DECISION, CONDITIONS, FINDINGS OF FACT AND CONCLUSIONARY FINDINGS OF THE MCMINNVILLE HISTORIC LANDMARKS COMMITTEE FOR THE APPROVAL OF ALTERATIONS TO A HISTORIC LANDMARK LOCATED AT 714 SE WASHINGTON STREET

- DOCKET:** HL 4-19 (Certificate of Approval for Alteration)
- REQUEST:** Approval of alterations to an existing historic landmark and building that is listed on the McMinnville Historic Resources Inventory as a "Significant" historic resource (resource number B886). The proposed alterations include replacement of vinyl windows with wood windows, replacement and enlargement of doors, replacement and expansion of a deck on the side and rear of the building, addition of an open wood trellis above the deck, and the addition of a new detached two car garage with an accessory dwelling unit above the garage.

- LOCATION:** 714 SE Washington Street. The property identified as Tax Lot 10500, Section 21CB, T. 4 S., R. 4 W., W.M.
- ZONING:** R-4 (Multiple Family Residential)

The proposed alterations and addition of a new garage are identified in the submitted elevations below:

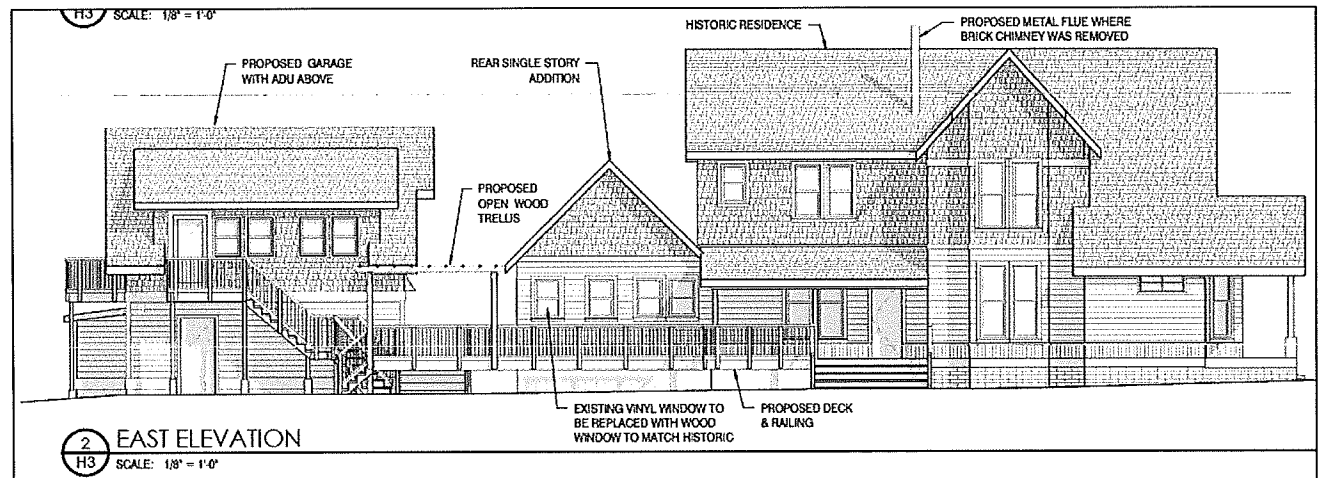
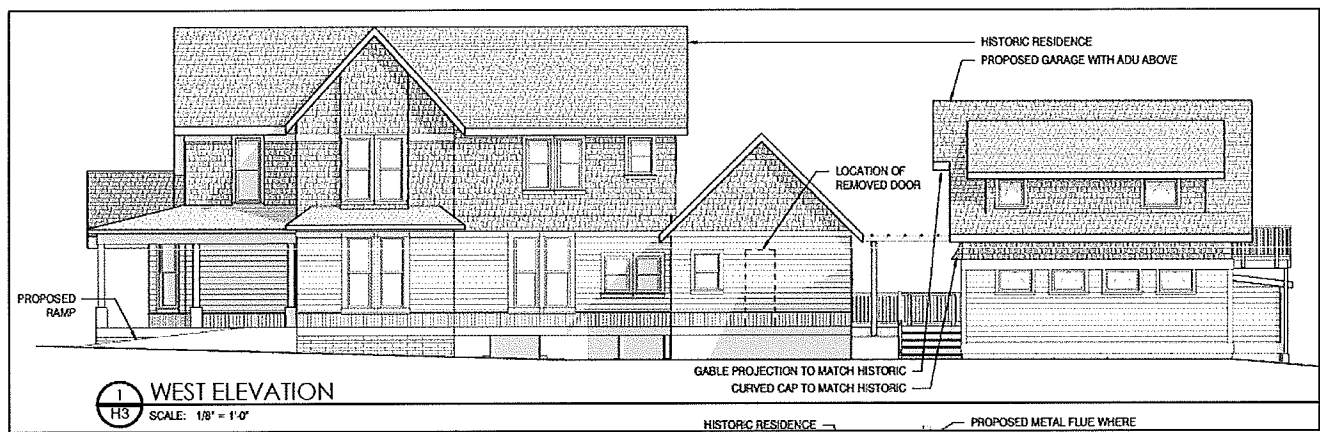
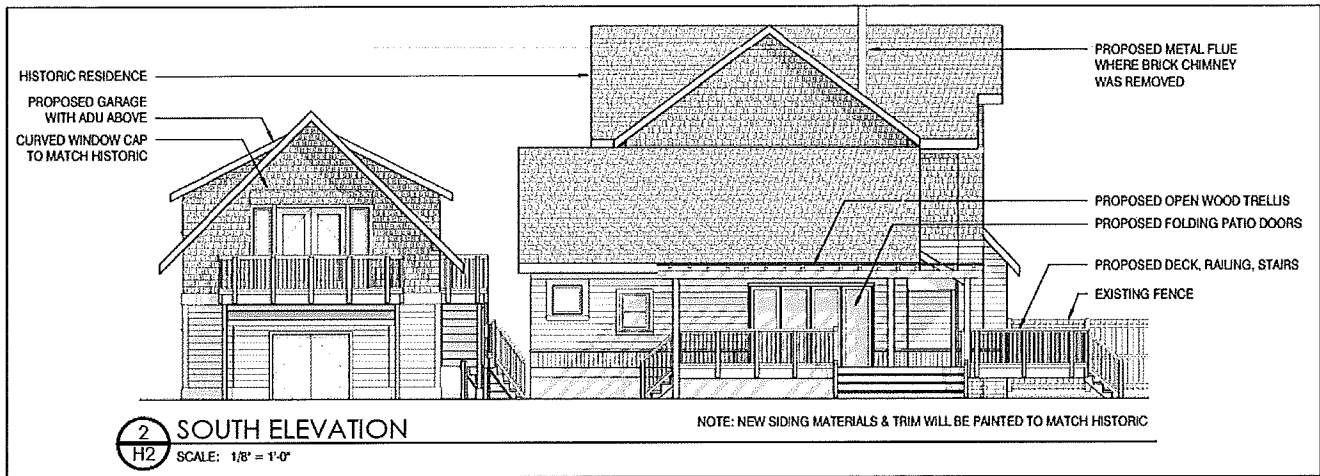
At east elevation, the new deck is not a concern, but the stair to the deck appears to have inadequate head height at the stair landing under the existing porch roof. It may be inadequate currently but if re-built, the stair must have a minimum of 6'-8" of head height measured from the stair nosing and the entire landing area.

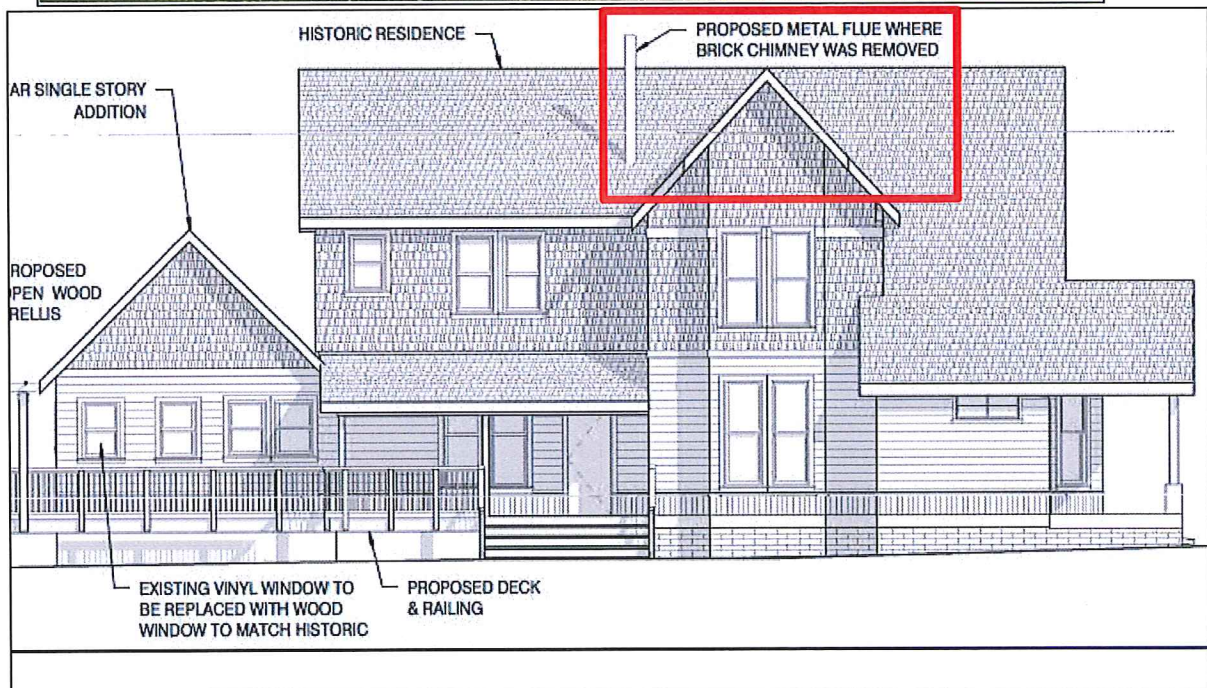
There is one remaining chimney that is proposed to be removed and replaced with a metal flue. The applicant has noted that this metal flue would not be visible from the street. However, the height of the metal flue projects above the height of the roof, and the material of the metal flue is not consistent with the historic character of the property. Therefore, a condition of approval

is included to allow the internal changes and the addition of the wood burning stove and metal flue, but require that the metal flue be encased in either the repaired brick chimney or a new brick chimney that replicates the existing chimney that is still present on the historic residential structure. The location and height of the proposed metal flue can be seen below:

1. The existing brick chimney shall either be repaired or replaced by a similar brick chimney that will encase the proposed metal flue associated with the addition of a wood burning stove in the historic residence. The repaired or new brick chimney should match the existing chimney in height, depth and any assorted brick design.

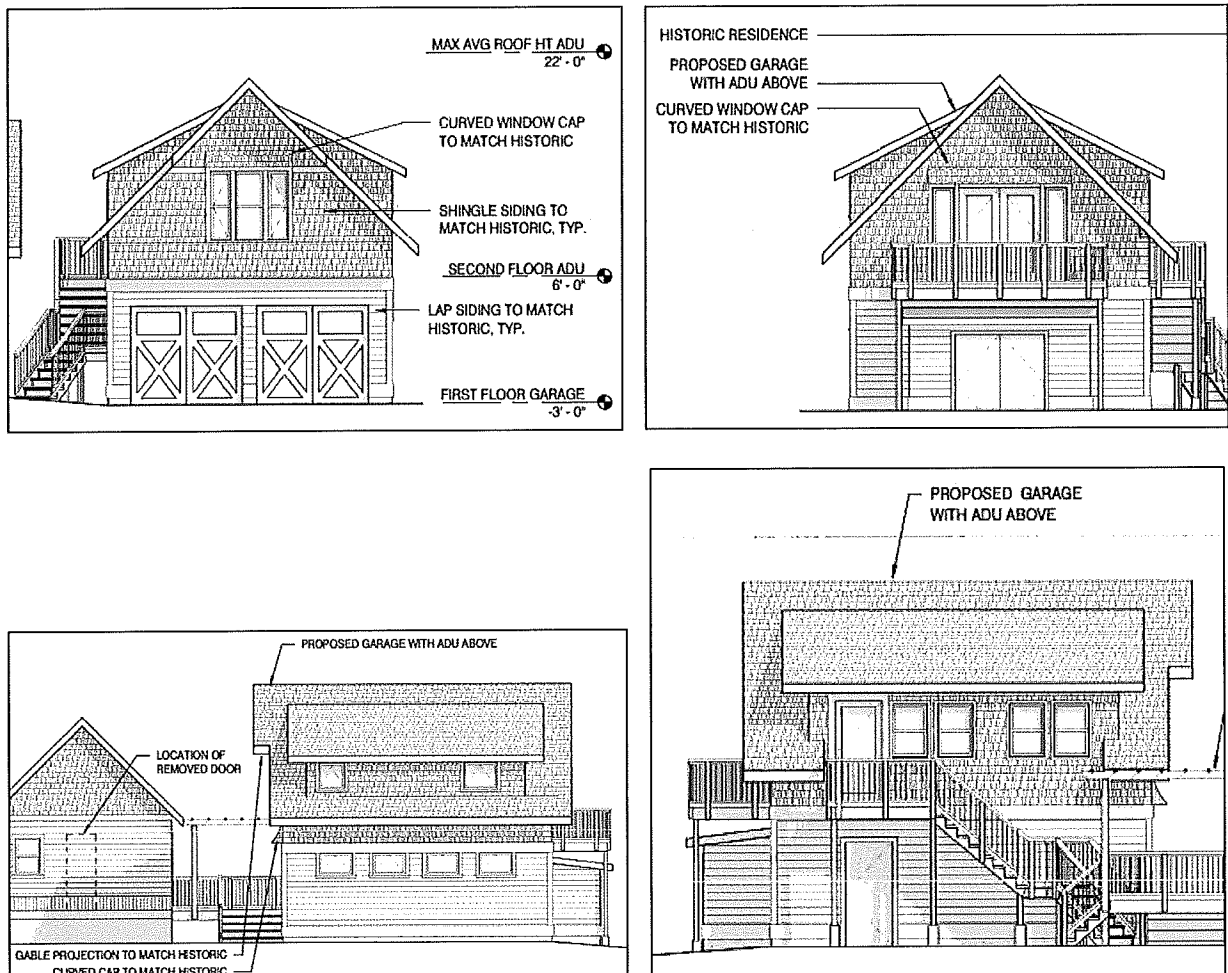
The addition of the garage and Accessory Dwelling Unit (ADU) is being proposed in a detached structure, which will not add to or alter the existing historic residential structure. The new garage and ADU are proposed to be located at the rear of the property, which will not detract from the existing spatial relationship of the existing historic residential structure on the property. The historic residential structure remains as the primary structure on the site by being prominently located closer to the street and public right-of-way. The ADU is proposed to be designed in such a way as to complement and coordinate with the existing historic residential structure as well. This is also required by Section 17.21.010(D) of the McMinnville Municipal Code, as described by the applicant, in that the appearance of the ADU must coincide with the primary dwelling and structure on the property. The ADU is proposed to coincide by including the same siding, roofing, roof pitch, and also incorporating the curved cap detail that exists on the main historic structure over the larger second story windows and the slight gable projection. The City would note that the elevation drawings note that the maximum average roof height of the ADU is 22 feet. However, the City measures building height from grade to the highest point of the structure, which results in the ADU being approximately 23.5 feet in height. The main home is approximately 29 feet in height, so the ADU height at 23.5 feet is in compliance with the height requirements of Section 17.21.010(D) of the McMinnville Municipal Code. The design of the ADU can be seen below:

The ADU is proposed to coincide by also including a replication of the curved cap detail that exists on the main historic structure over the larger second story windows and the slight gable projection on the north façade of the ADU. However, the City finds that the replication of this feature makes the new construction too compatible with the existing historic resource. Therefore, a condition of approval is included to require that the final plans for the new garage and ADU that are submitted for building permit review do not include the decorative curved cap detail to ensure that the new construction is differentiated from the existing historic structure.

4. That the construction plans submitted for building permit review for the new garage and Accessory Dwelling Unit (ADU) shall not include the decorative curved cap detail that exists on the existing historic structure over the north façade windows.

The existing door can be seen below:

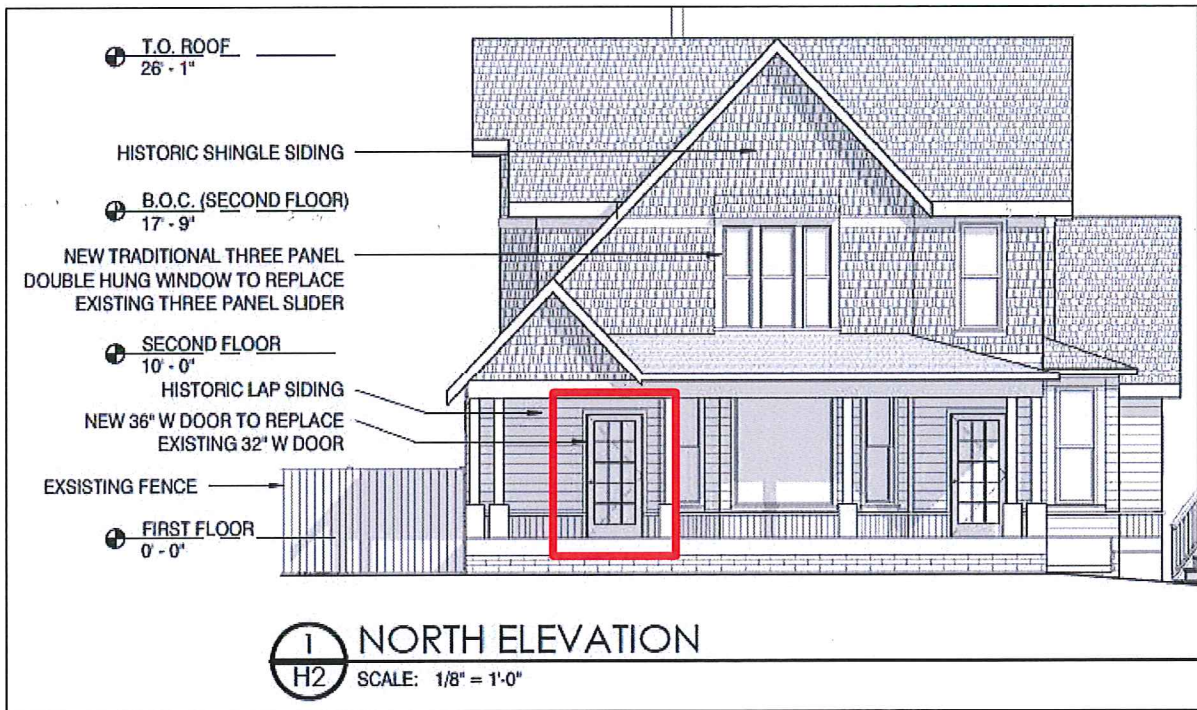
Another condition of approval is included to require that the new front door be consistent in style with the western door of the two front doors on the street-facing façade of the structure. Both of the front doors used to contain a grid system within a large glazed portion of the door. However, today only the western door contains the grid system and glazing. It appears that the eastern of the two doors, which is now proposed to be replaced and enlarged, was somewhat recently replaced with a more modern door that does not include glazing. The existing door is proposed to be replaced to allow for the installation of a wider door that meets accessibility requirements for the proposed bed and breakfast use that will be located within the structure. The glazed door existed as late as August of 2012, as shown in the Google street view photo:

The condition of approval will require that the new door match the old door in material and design. The location of the new front door can be seen below:

3. That the new front door be consistent in style with the existing door being replaced. The new door shall include the glazing pattern and grid system within the glazed portion of the door, and shall match the other existing front door on the street-facing façade of the structure in design, materials, and color.
